Fakhruddin Textiles Mills Limited (Extension Area)

25 February & 11 August 2021

Observations

Observations: Building 09- Store & Dining building

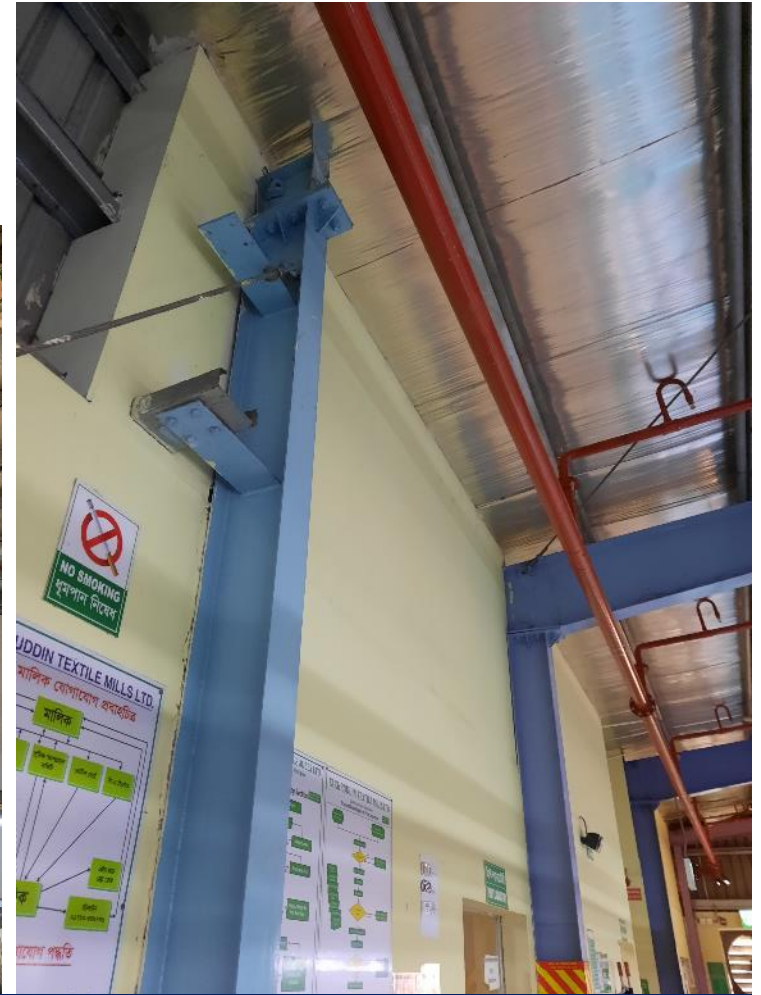
Implement floor loading management program

No load management programs were visible. No load plan posted, load restriction height marking provided. Factory is required to implement load management program as per its floor loading capacity and Follow the load plans for all floors of the buildings and make sure that the workers understand the loading requirements.

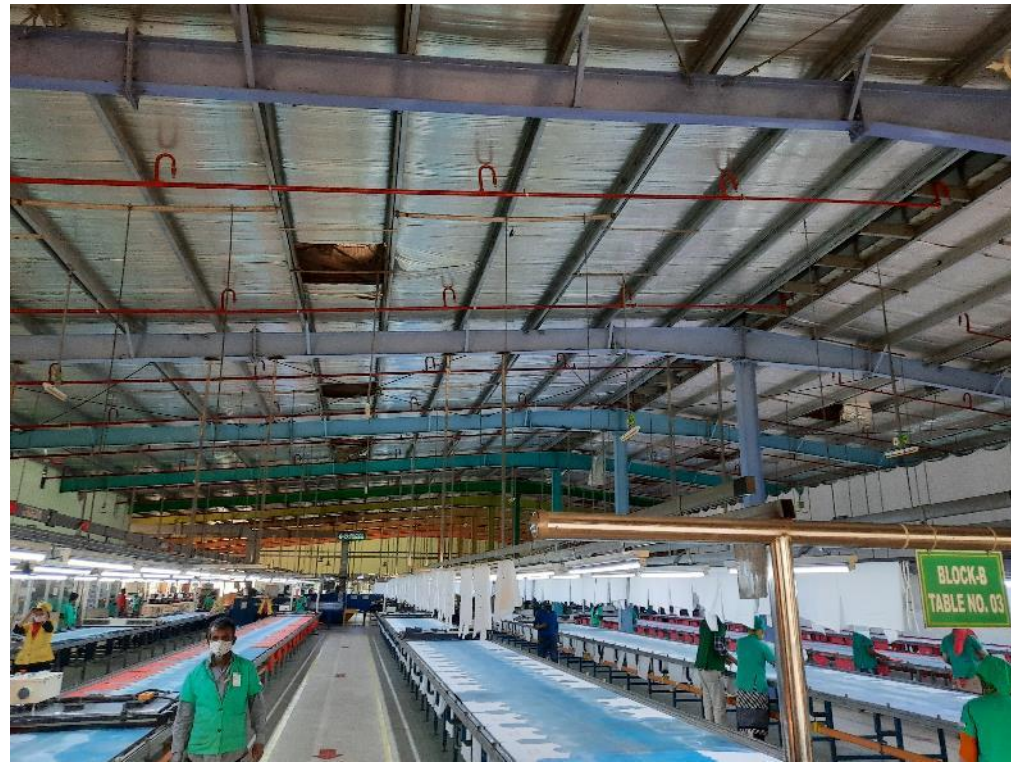
Absence of load transfer media in the long direction

No compression strut/Load transfer media has been provided in the long direction. No design report was available on site. Building engineer is required to check the requirement of the any load transfer media in the long direction.

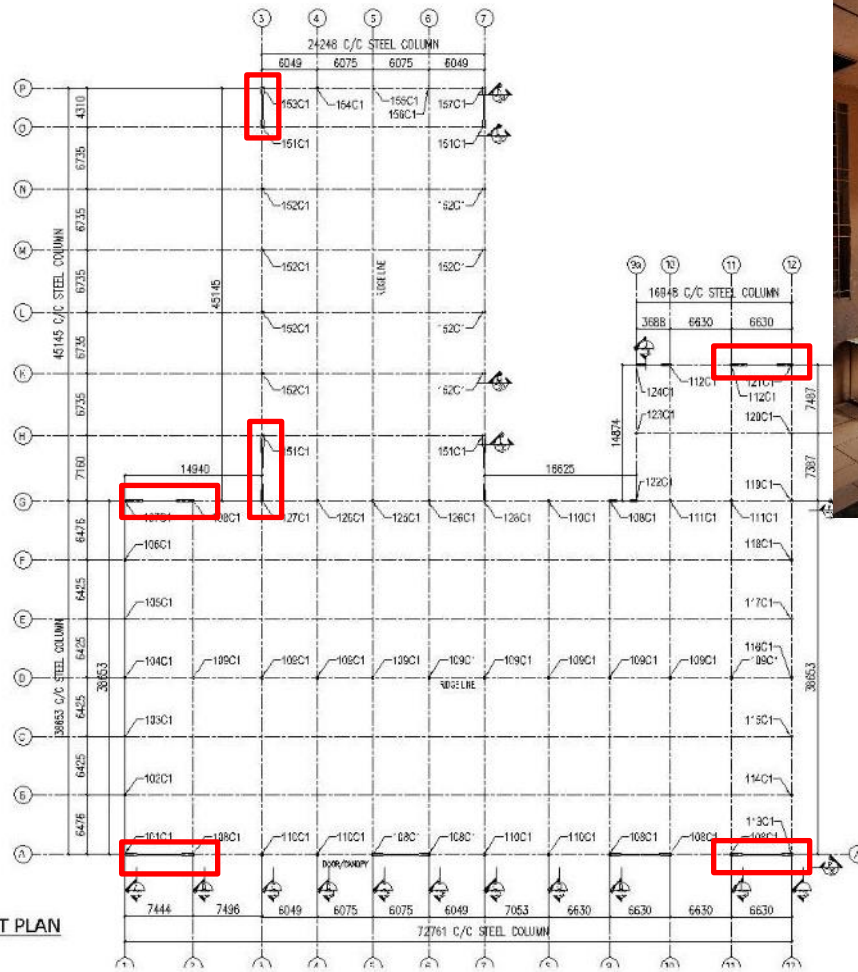
No design report was available for printing shed

Column & Vertical bracing layout plan

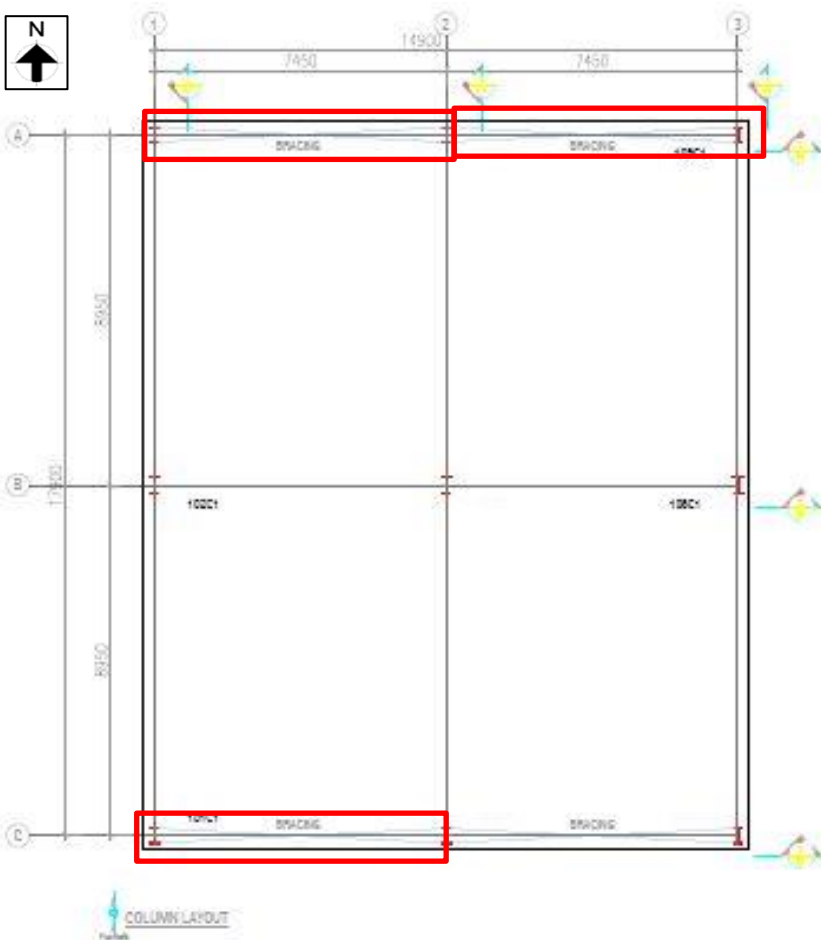
Vertical bracing missing

Vertical bracing found missing in several location.

Vertical bracing missing in several location

Column & Bracing Layout plan

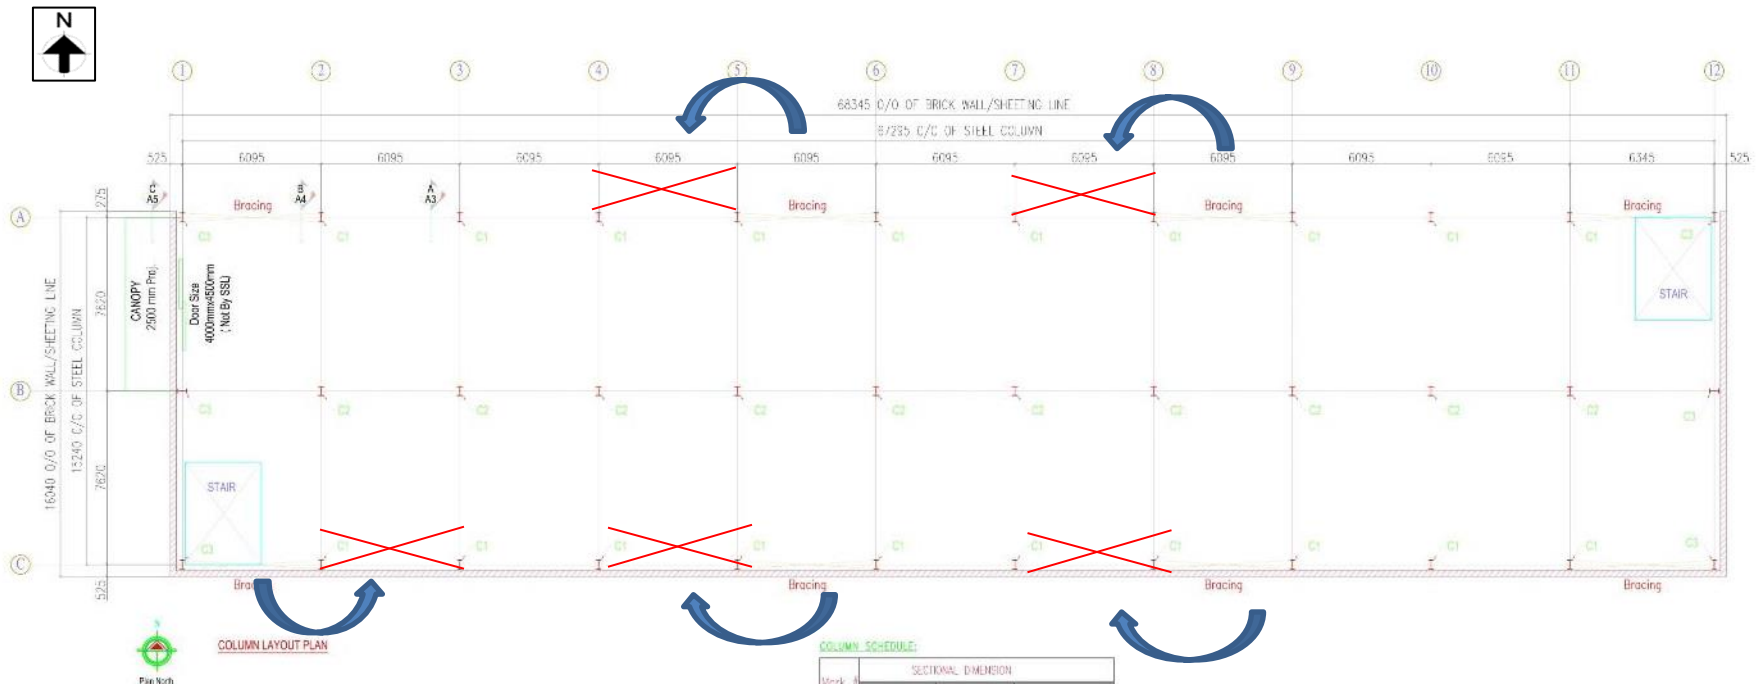
Vertical bracing found missing in several location. Building engineer is required to check the lateral stability of the building.

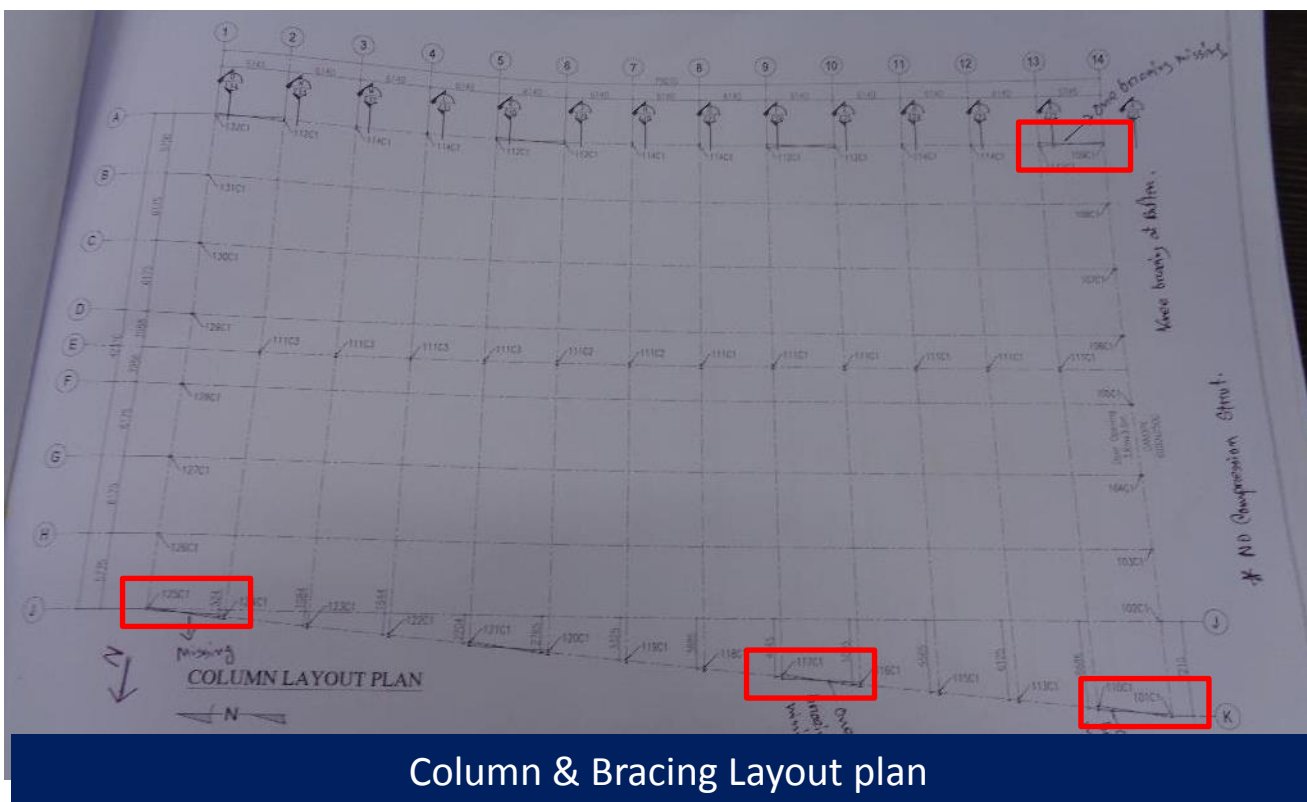
No design report was available for Garments Dyeing & Seamless Shed
